CITY OF WEST DES MOINES BOARD OF ADJUSTMENT COMMUNICATION

Item: Willow Creek Baptist Church - 720 Army Post Road – Approval of a Permitted Conditional Use Permit to allow an approximately 13,000 square foot building addition; PC-002549-2014

Requested Action: Approval of a Permitted Conditional Use Permit

WILLOW CREEK BAPTIST CHURCH CHURCH ADDITION

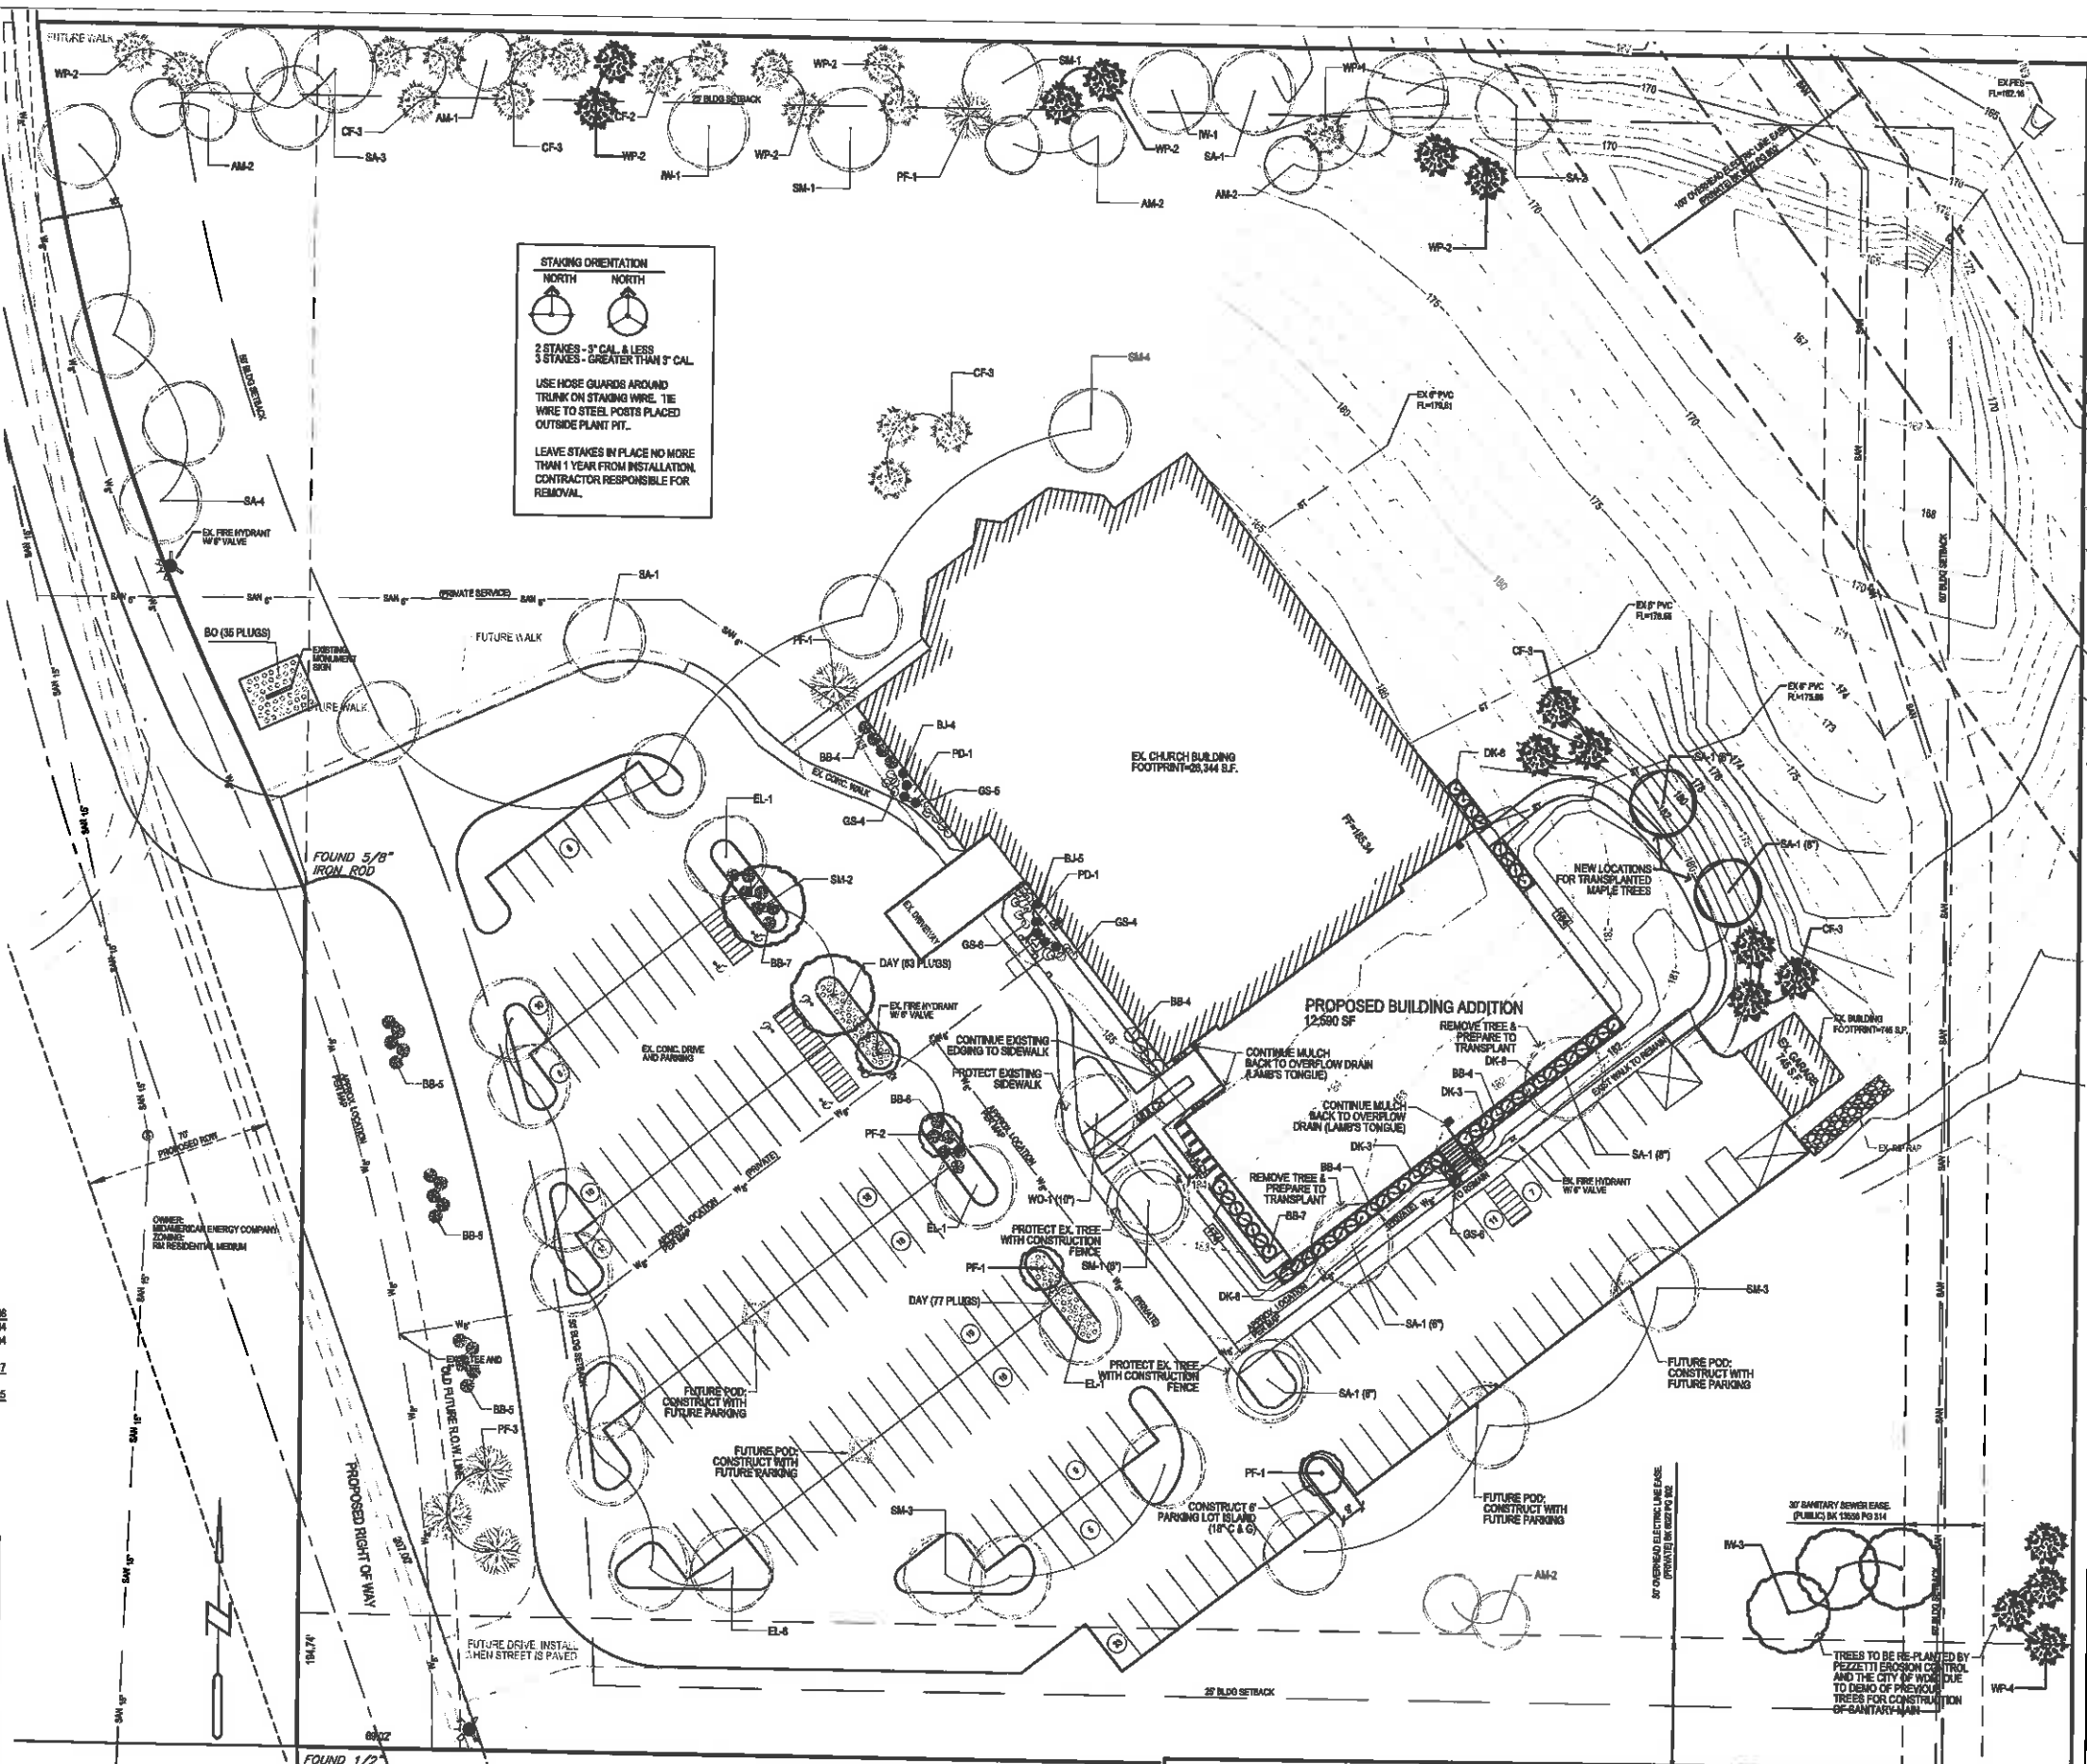
- ***Parking Lot Landscape Pod Deferral:*** City Code requires landscape pods (or tree diamonds) within a parking row spaced no farther than 9 parking spaces from another landscape pod or landscape island. There are currently no landscape pods within the existing parking lot. To be in compliance with current Code requirements, landscape pods are required in four (4) locations within the parking lot. Since there are no plans to make any modifications to the existing parking lot with this project and since the existing soil under the parking lot will be compacted and may not contain the required nutrients for a tree to survive, the applicant is requesting a deferral to install the required landscape pods within the parking lot until such time that the parking lot is modified, expanded or reconstructed in the future. Staff recommends a condition of approval requiring that landscape pods be installed at such time that the parking lot is resurfaced or expanded.

1. A deferral is granted to defer construction of four landscape pods as designated on the approved site plan until such time that the parking lot is modified, expanded or reconstructed in the future.
2. The City Council granting a deferral of the installation of sidewalks along the east side of the future S8th Street. The Specific duration of the deferral to be determined by the City Council. If the deferral is not granted, the applicant shall install the sidewalk in conjunction with the construction of the building addition.
